## **RIVERWOOD SUBDIVISION, PHASE TWO**

APPLICATION NUMBER 16 DATE June 16, 2005  
APPLICANT Riverwood Subdivision, Phase Two  
REQUEST Subdivision

## DETAIL SITE PLAN

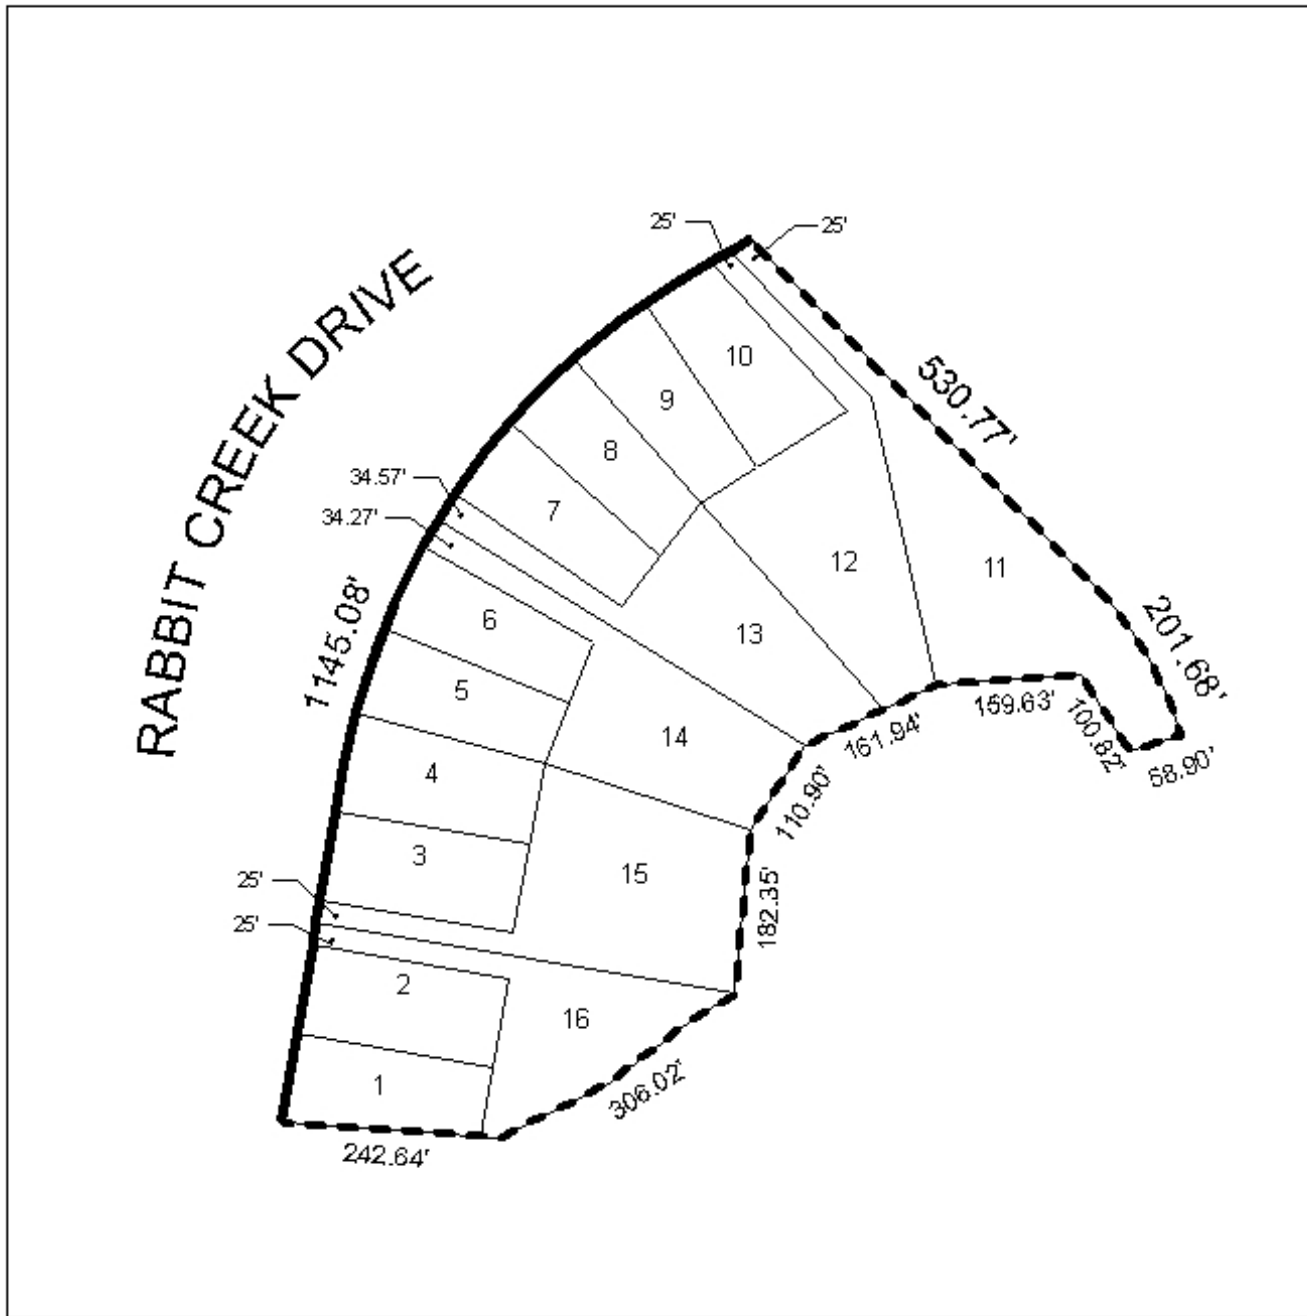
The site fronts Rabbit Creek Drive, a minor street which has a right-of-way width of 60 feet. Rabbit Creek Drive predominantly serves residential uses, therefore access from the site to Rabbit Creek Drive is a concern. As designed, the proposed subdivision may have up to 16 curb-cuts onto Rabbit Creek Drive; as approved in 2004, the area in question would have had access via one street that intersected with Rabbit Creek Drive. It should be noted, however, that the originally proposed street access served a much larger number of lots within the proposed subdivision; thus direct comparison of this subdivision application with the 2004 design is not feasible. It is recommended that the proposed Phase Two subdivision be required to share curb-cuts, with a total of eight curb-cuts for the 16 proposed lots. The location, size, and design of curb-cuts must be approved by County Engineering.

Six of the proposed lots are flag-shaped, and have a minimum 25-foot wide strip providing frontage access to Rabbit Creek Drive. While the use of flag-lots would be uncharacteristic for the area, according to Section V.D.1. of the Subdivision Regulations, existing development and the presence of extensive wetlands precludes most options for the site. The flag-lots also do not conform to the depth to width ratios of Section V.D.3. due to the minimum 25-foot wide access strip. Due to the restrictions of adjacent development and the presence of wetlands, a waiver of Sections V.D.1. and V.D.3. could be considered appropriate.

The 25-foot minimum building setback line, required in Section V.D.9., is not shown for the subdivision, but would be required on the Final Plat, if approved.

The site is within the drainage basin for Rabbit Creek, a tributary to Dog River. In addition to existing wetlands, a portion of the site appears to be located within floodplains associated with the Rabbit Creek. The presence of wetlands and floodplains on the site indicate that the area may be environmentally sensitive; therefore, the approval of all applicable federal, state and local agencies would be required prior to the issuance of any permits.

With a waiver of Sections V.D.1. and V.D.3., the plat is recommended for Tentative Approval subject to the following conditions: 1) placement of a note on the Final Plat stating that the lots are limited to a combined total of 8 curb-cuts, with curb-cut size, location and design to be approved by County Engineering; 2) approval of all applicable federal, state and local agencies regarding the wetlands and floodplain issues prior to the issuance of any permits; 3) depiction of the 25-foot minimum building setback line; and 4) placement of a note on the Final Plat stating that any lots which are developed commercially and adjoin residentially developed property must provide a buffer, in compliance with Section V.A.7. of the Subdivision Regulations.
